Central Valley Regional Water Quality Control Board  
5/6 February 2009 Board Meeting

Response to Comments for the  
Amador Water Agency, Pine Grove Community Leachfield System  
Tentative Waste Discharge Requirements  
Revised 11 January 2009

Figure 1 - Pine Grove Surface Water Monitoring-TDS

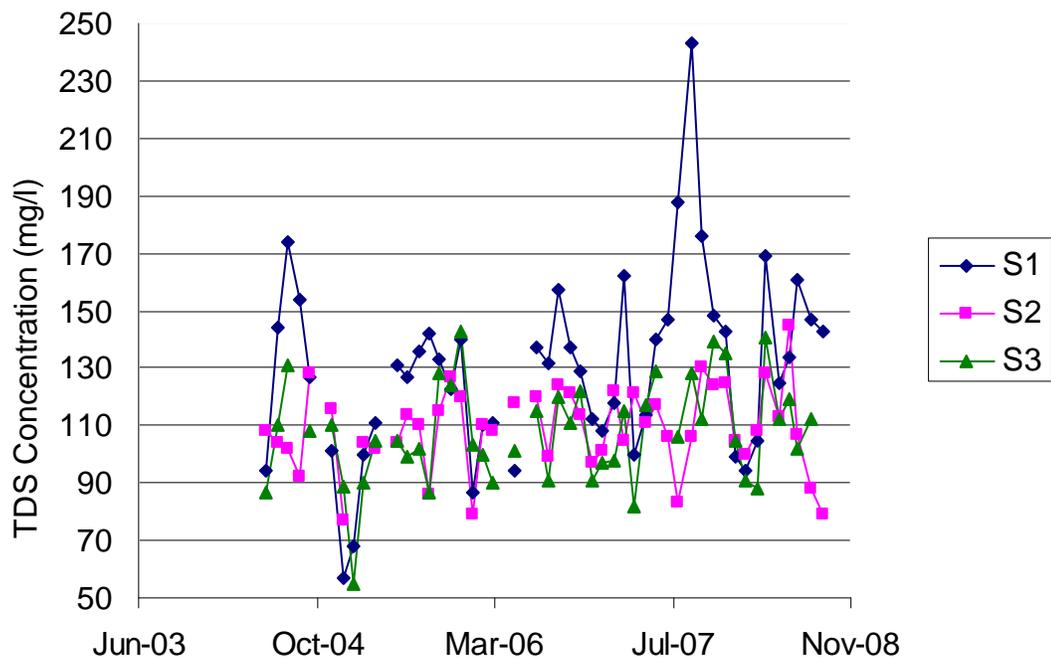
**Comment No. 6. Surface water monitoring** - Monitoring Reporting Program must be revised to include field for the (sic) observations receiving water. In addition, monthly monitoring must be conducted.

**RESPONSE:** The receiving water for this discharge is groundwater and not surface water. The monitoring data (Figure 1 through 3) demonstrate the discharge has not degraded the surface water. Therefore, the monitoring of surface water as stated in the proposed Order is appropriate and reasonable.
